ADDENDUM NO. #1

RE: ITB# 016-20 – The Banks Bid Package #6 – Lot 23 Park, Lot 23/27 Garage Signage & Security

Addendum to the Construction Documents

DRAWING NUMBER
A102B

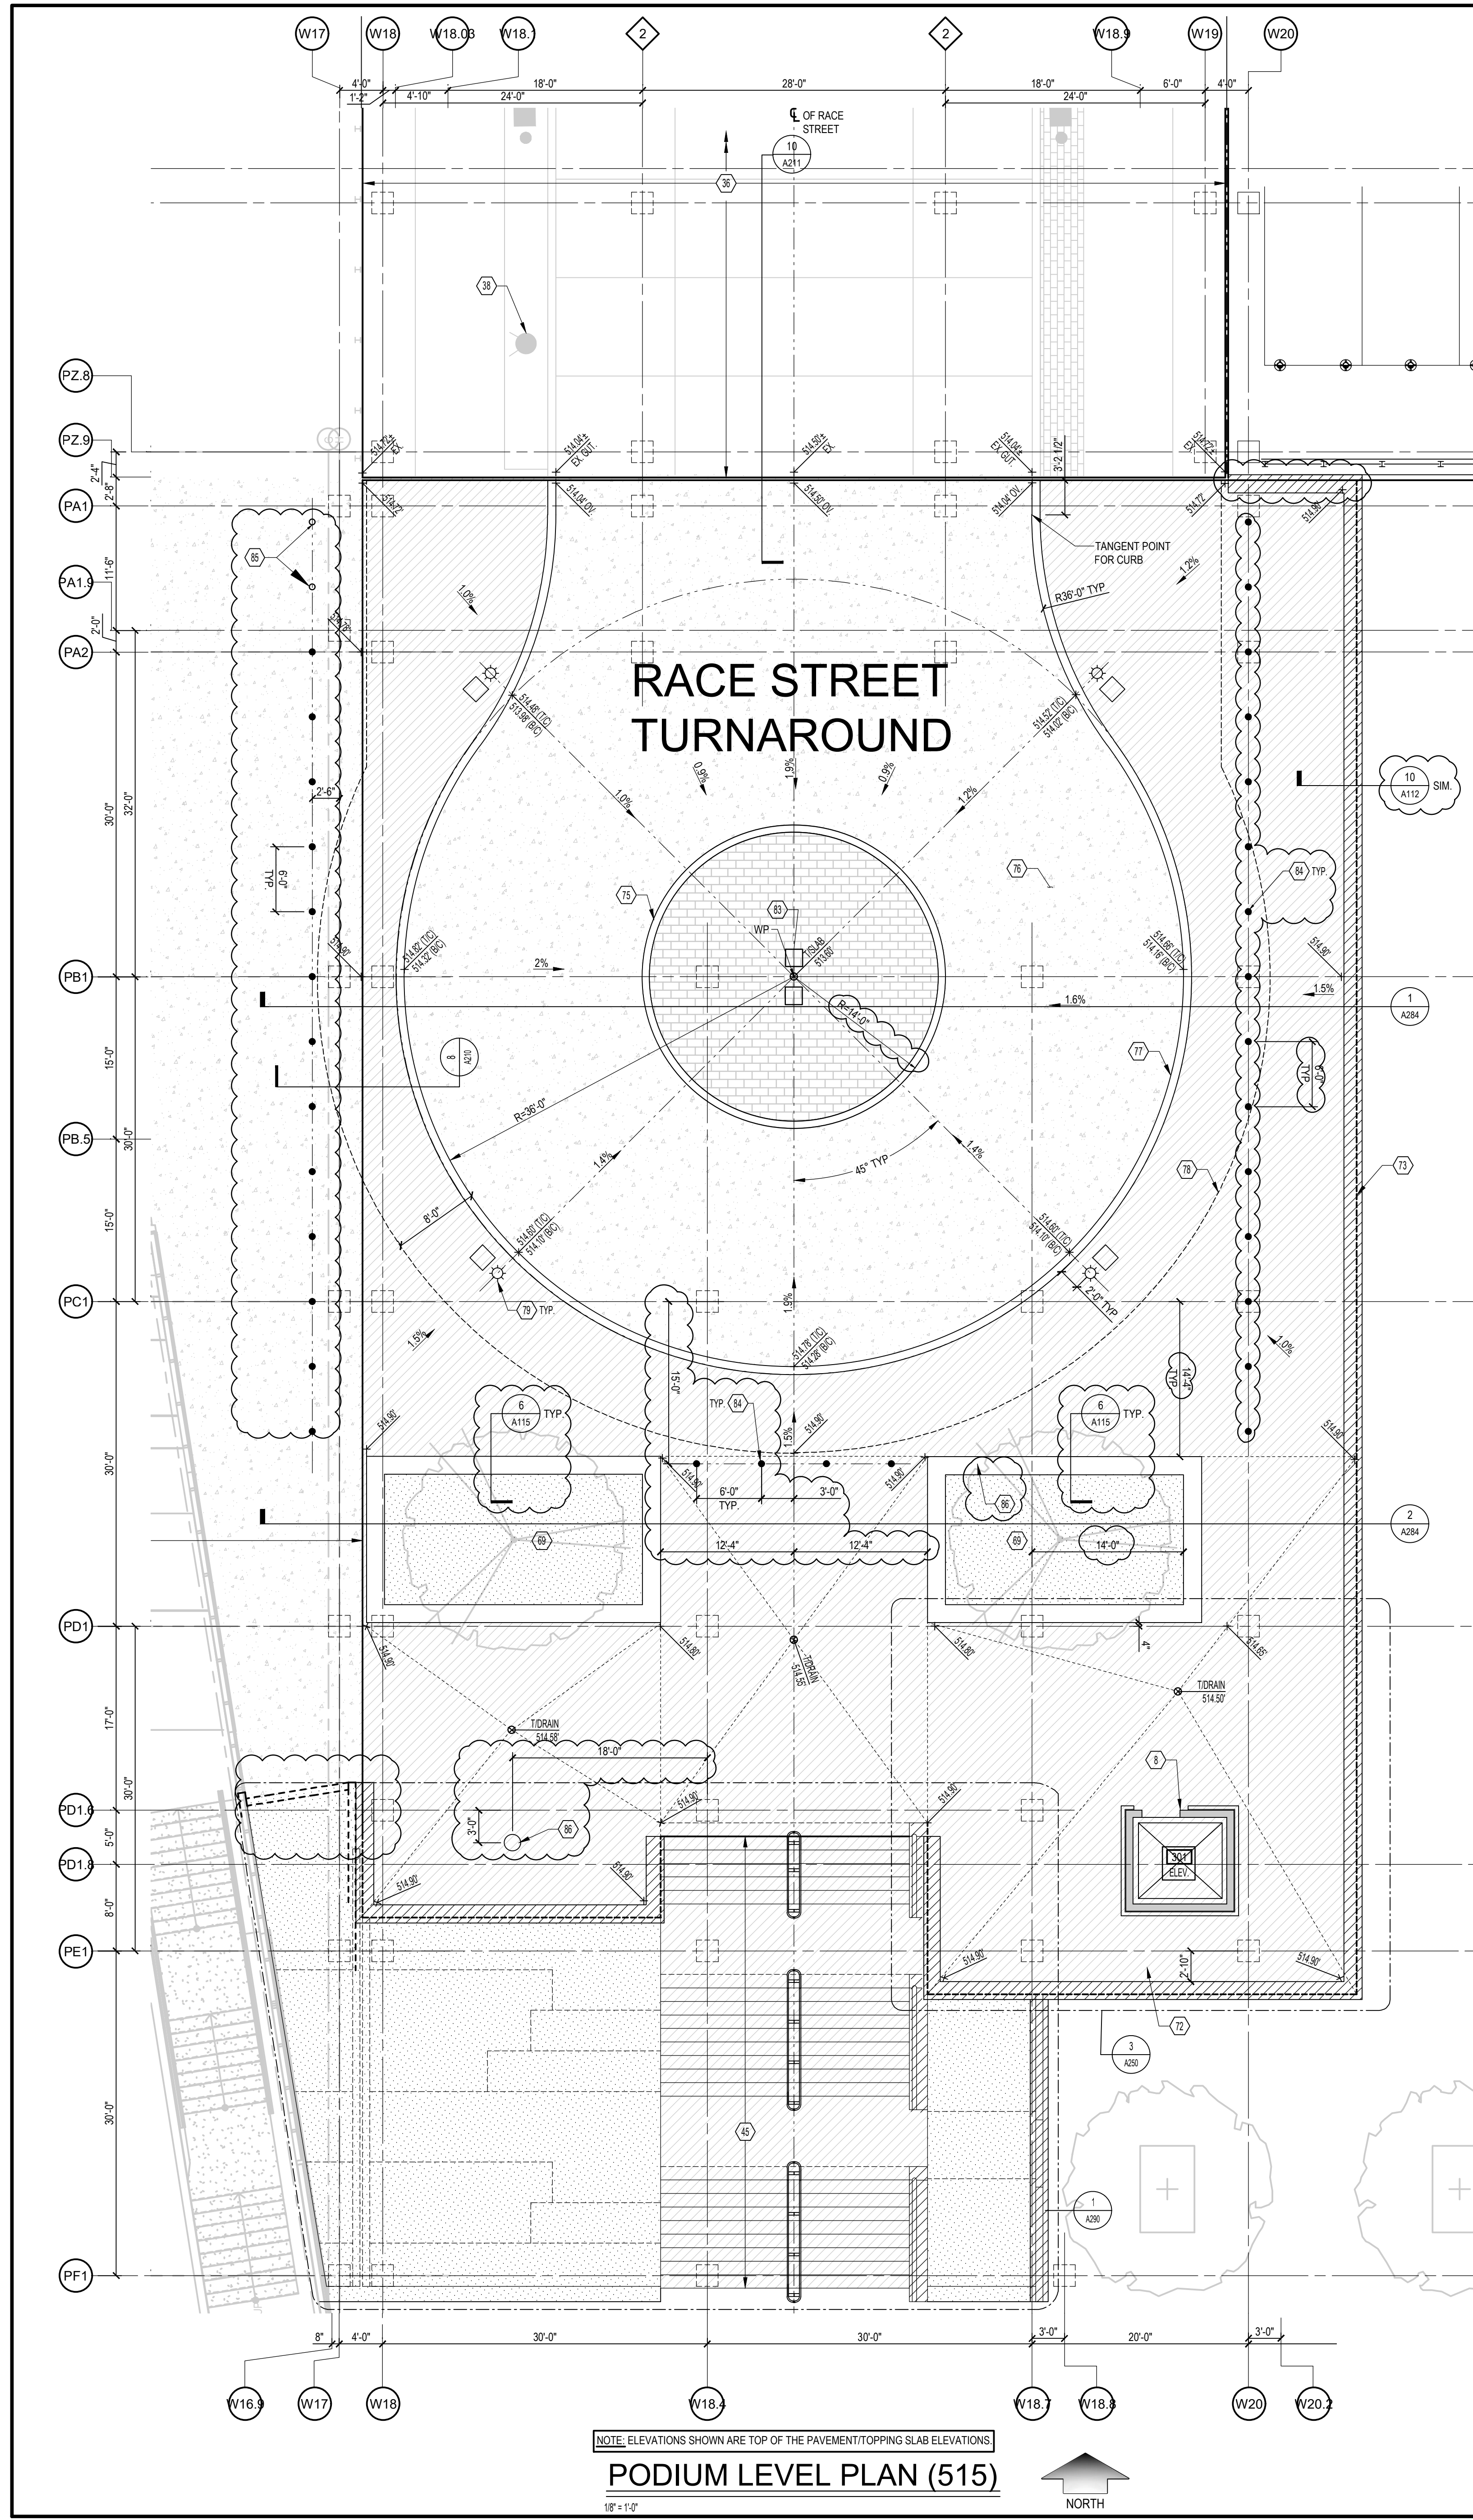
1. Drawing C101: (Drawing Reissued)
 - Updates to Note 13 and additional Note 14.
2. Drawing A102B: (Drawing Reissued)
 - Bollard location updates in Bulletin #10.
3. Drawing A103B: (Drawing Reissued)
 - Bollard location updates in Bulletin #10.
4. Drawing A110: (Drawing Reissued)
 - Bollard location updates in Bulletin #10.
5. Drawing A111: (Drawing Reissued)
 - Bollard location updates in Bulletin #10.
 - Additional light pole locations.

A115

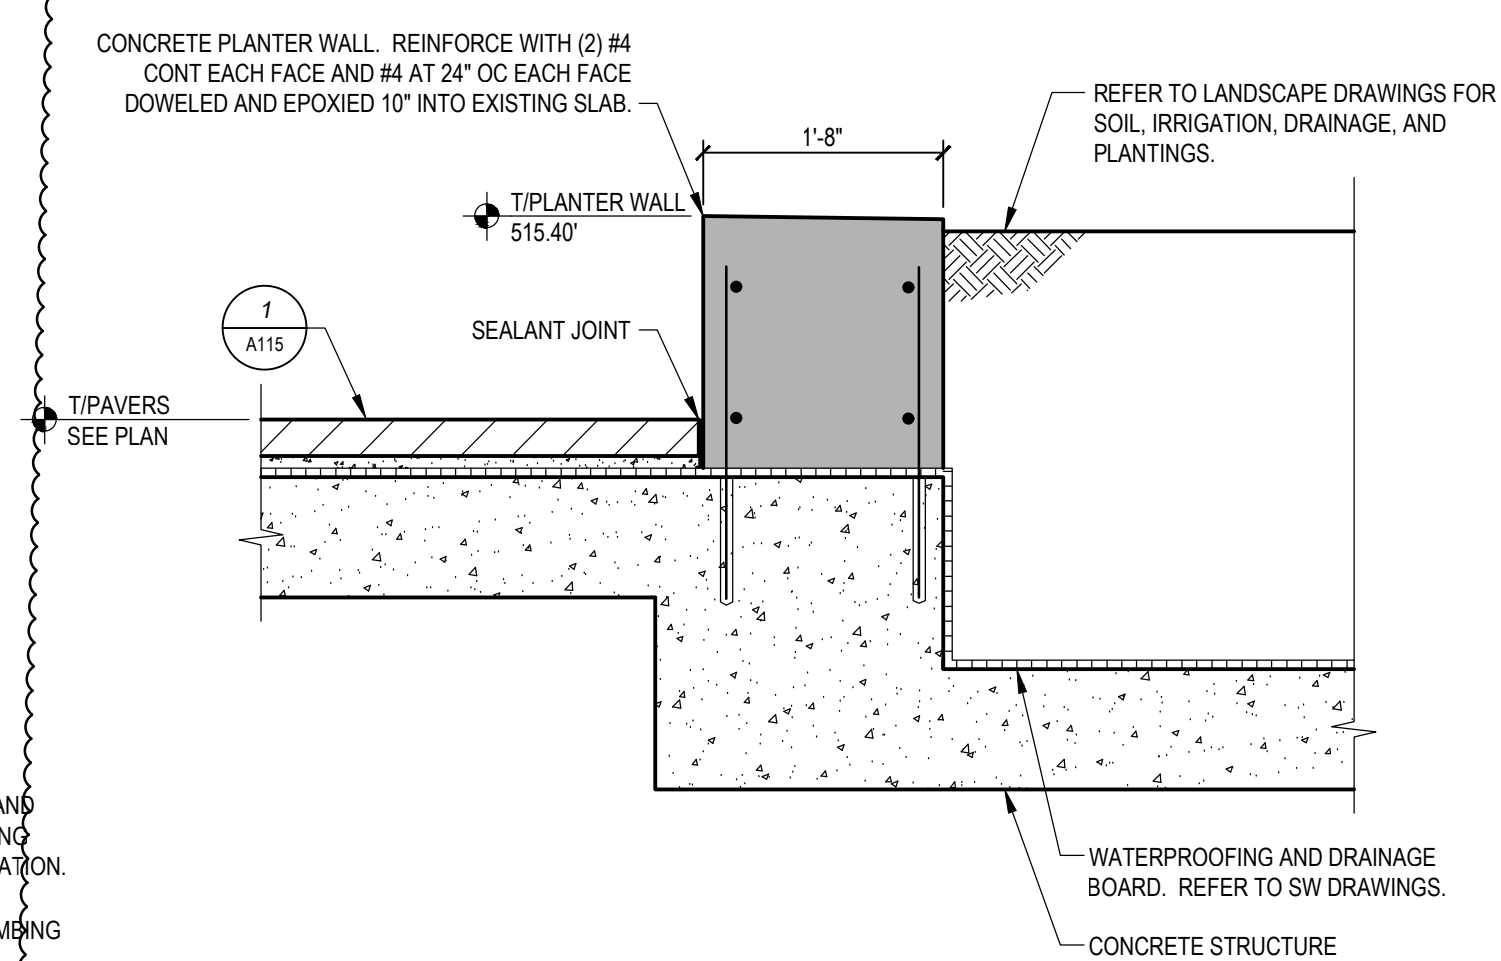
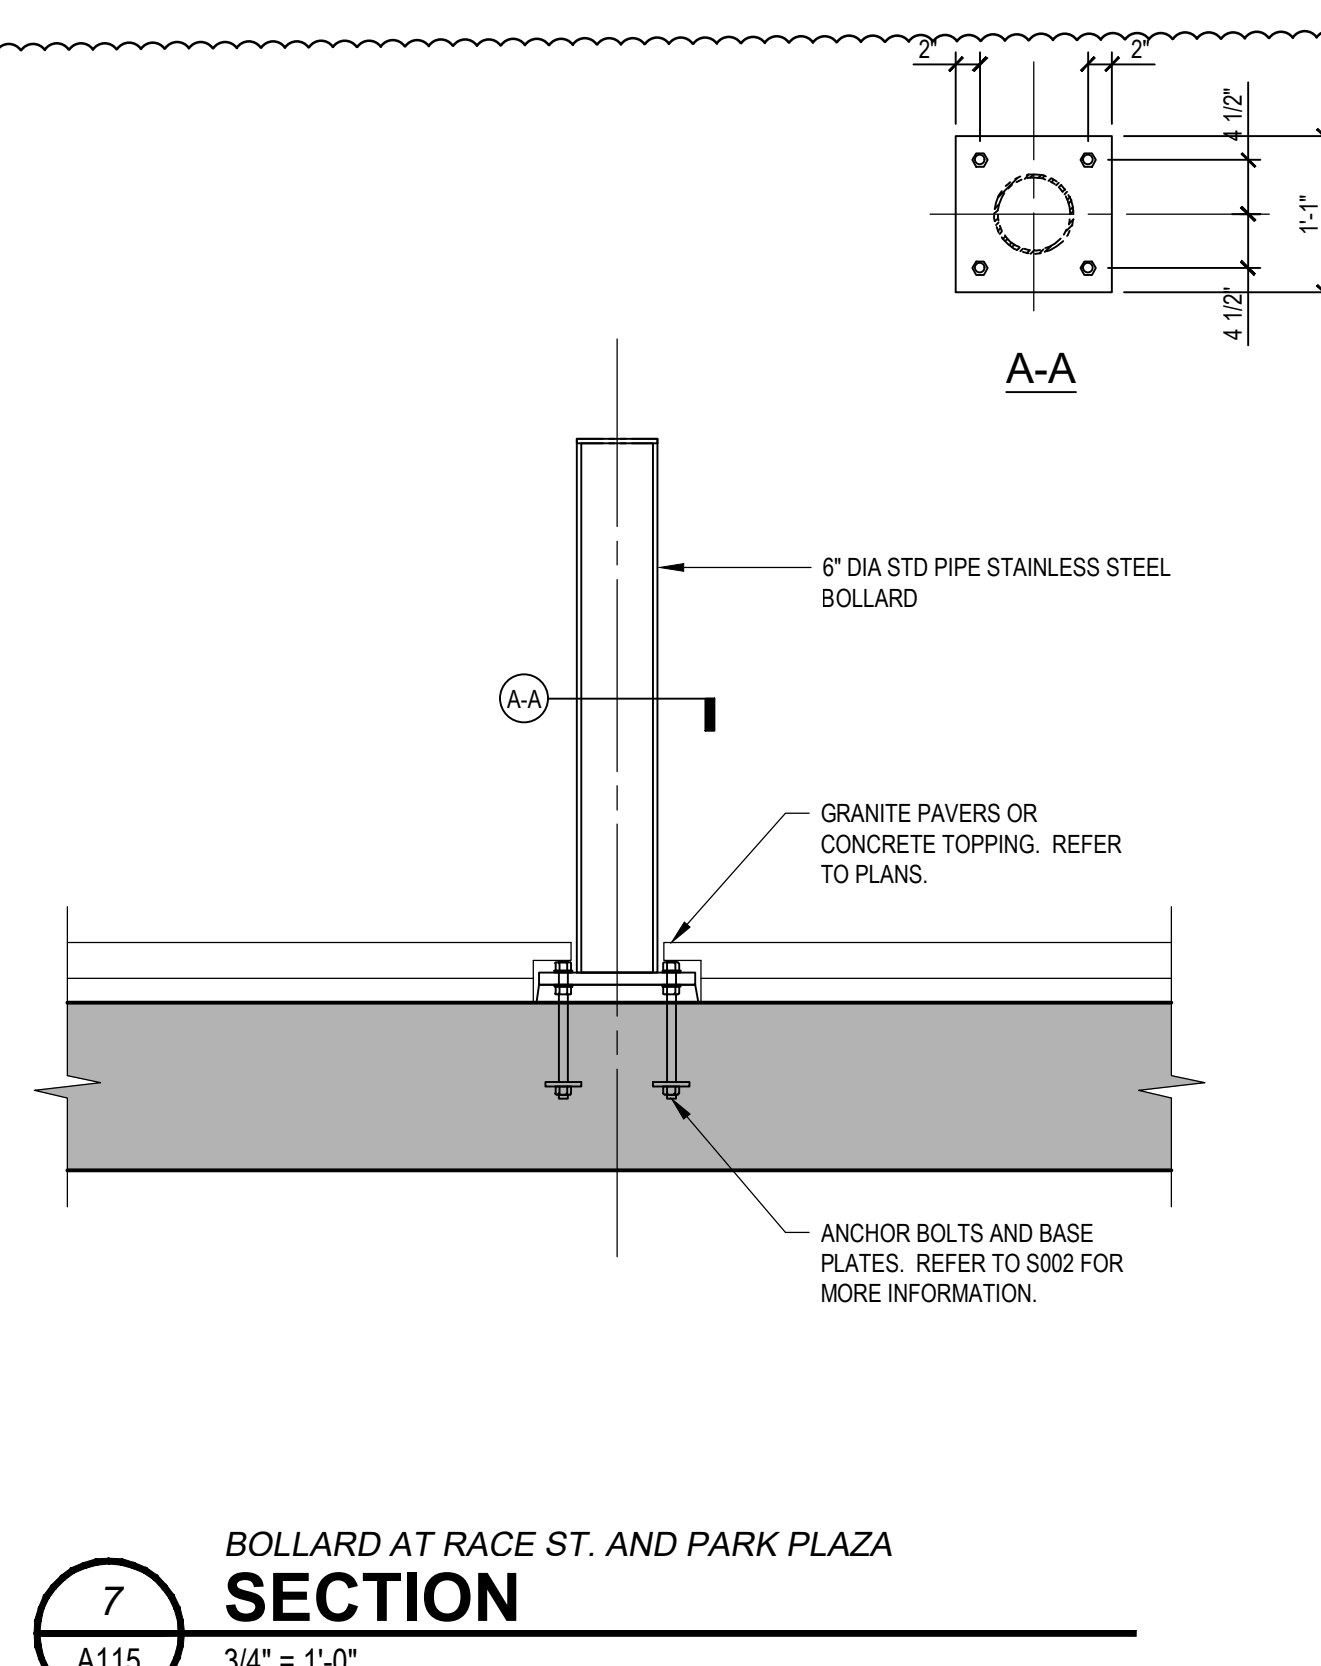
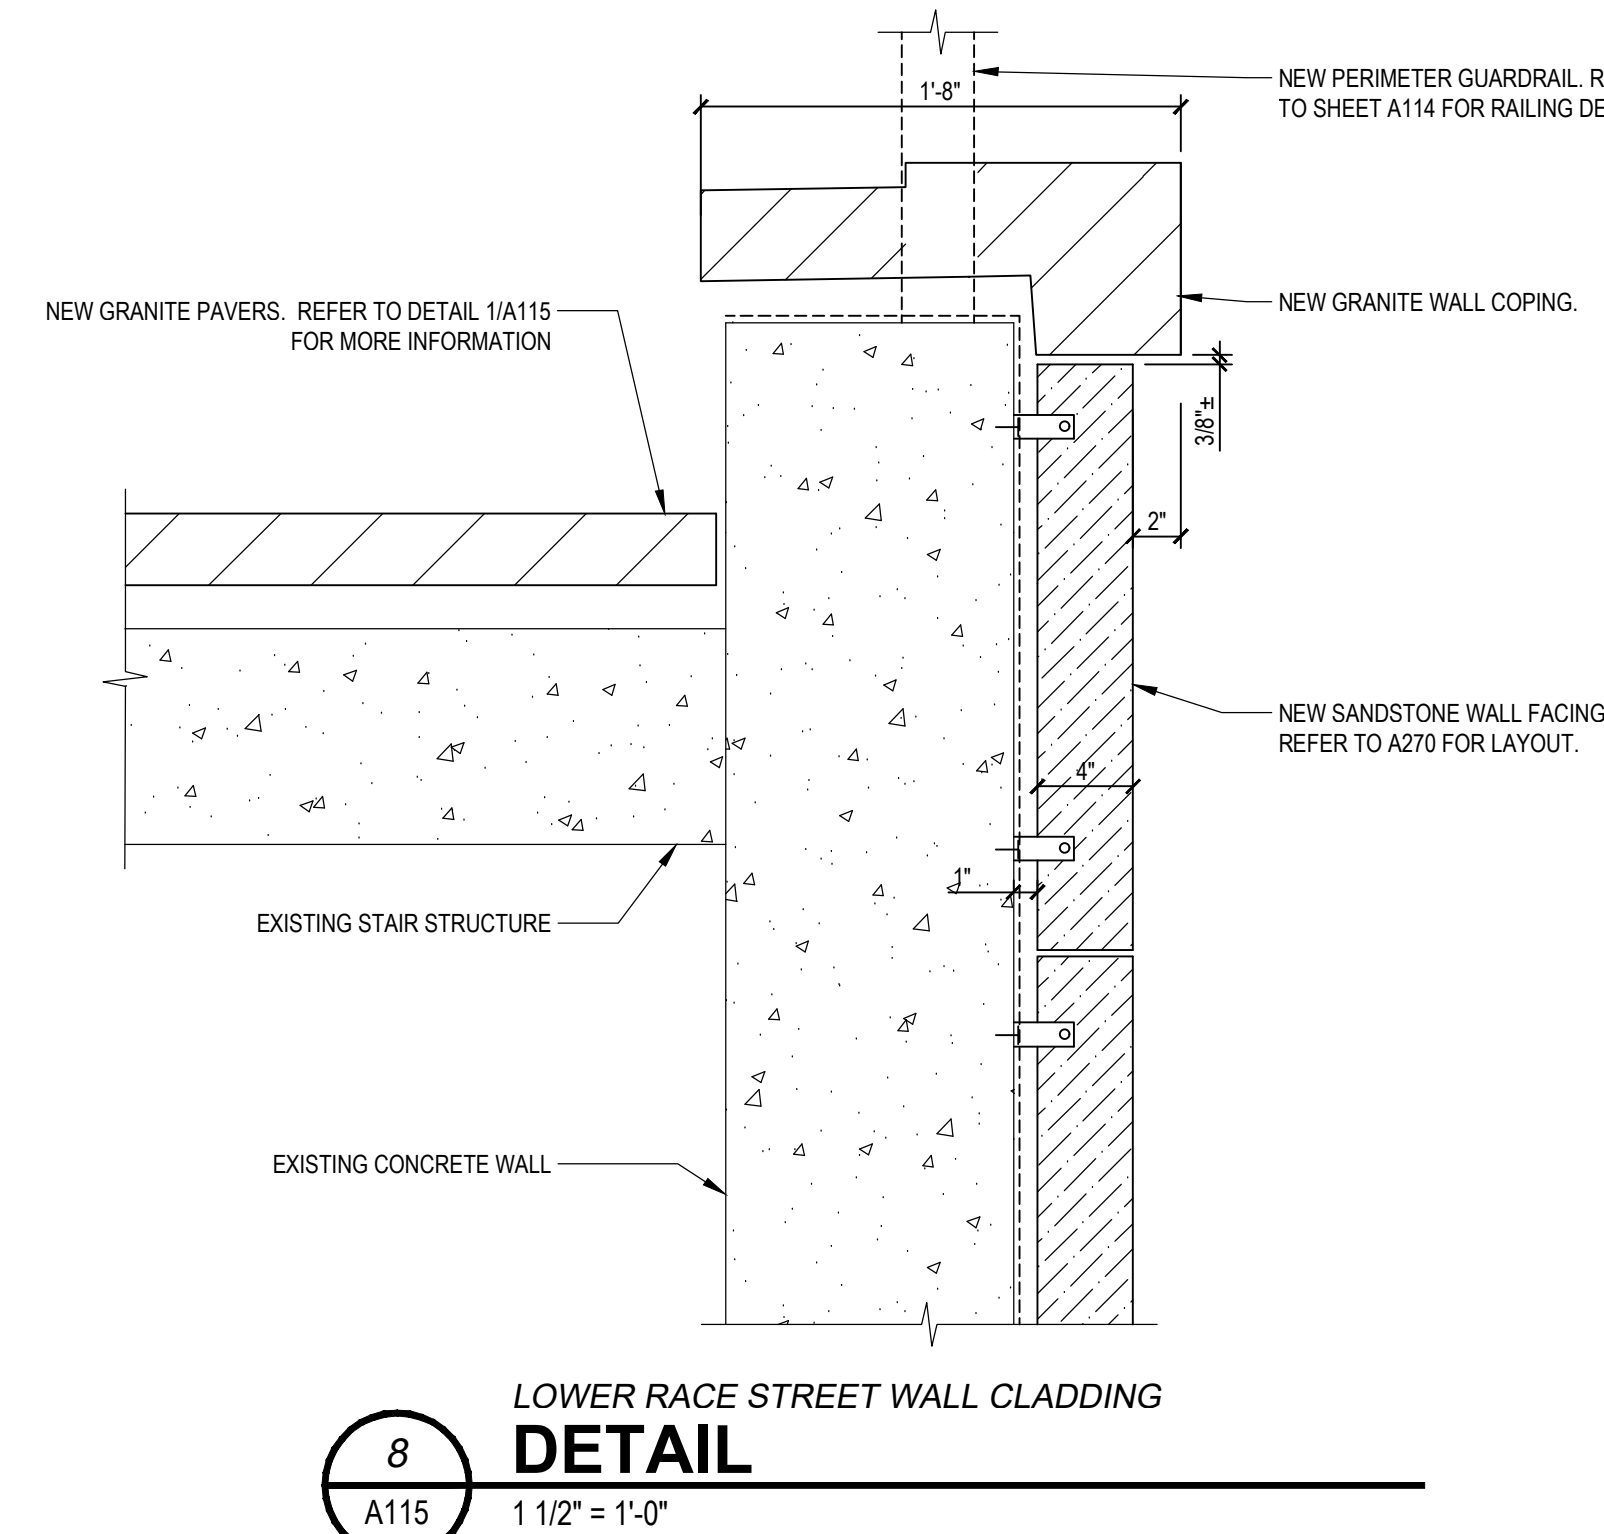
#12 Question: All of the railing noted in Detail 2 on A120 is called out as new, but the section views noted on Sheet A121 are confusing in relation to the plan views noted on A120. I am not finding a complete drawing detail in this bid set for the SS Lean Rail.

Answer: Extent of existing lean rail is shown on Plan 1/A120. All additional railing shown on Plan 2/A120 is new. Additional notes and detail to be added to Drawings A120 and A121 by addenda for clarification.
